Development Application **ACCESS REPORT**

Reference Number: 25028

Site Address: 3 Memory Avenue, Crookwell, NSW

This Access Compliance Report is to accompany a Development Application (DA) for the development proposed at **3 Memory Avenue, Crookwell, NSW**

[Image description: Ground floor Plan above shows the provision of Accessible parking spaces]

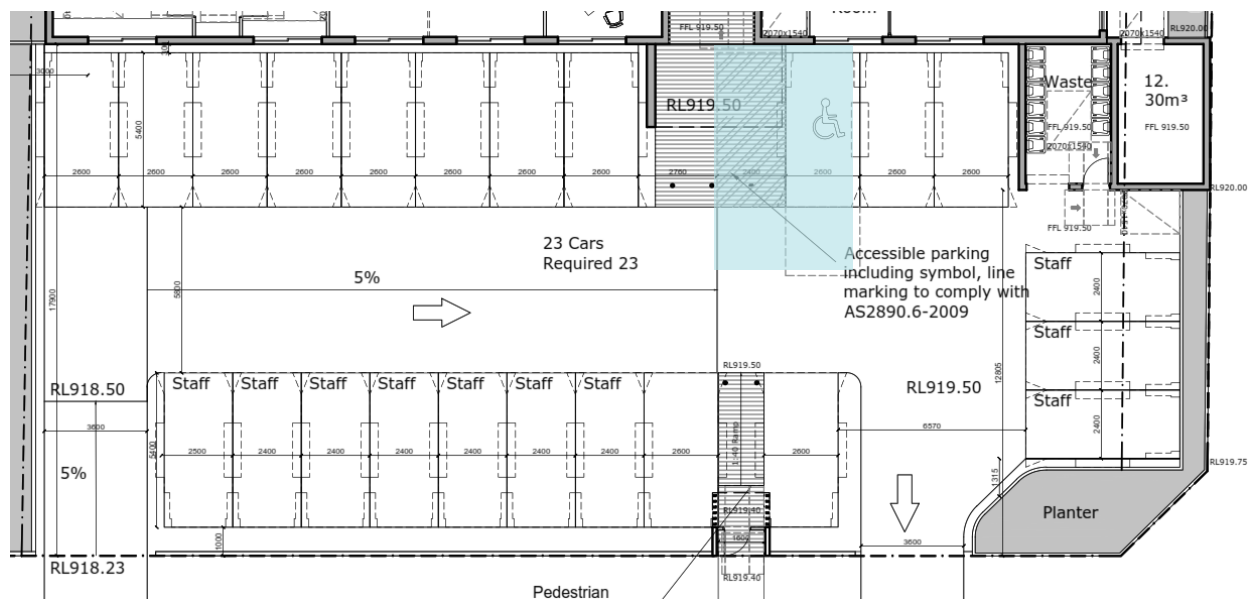
Total number of Accessible parking spaces required / provided in the development = 01
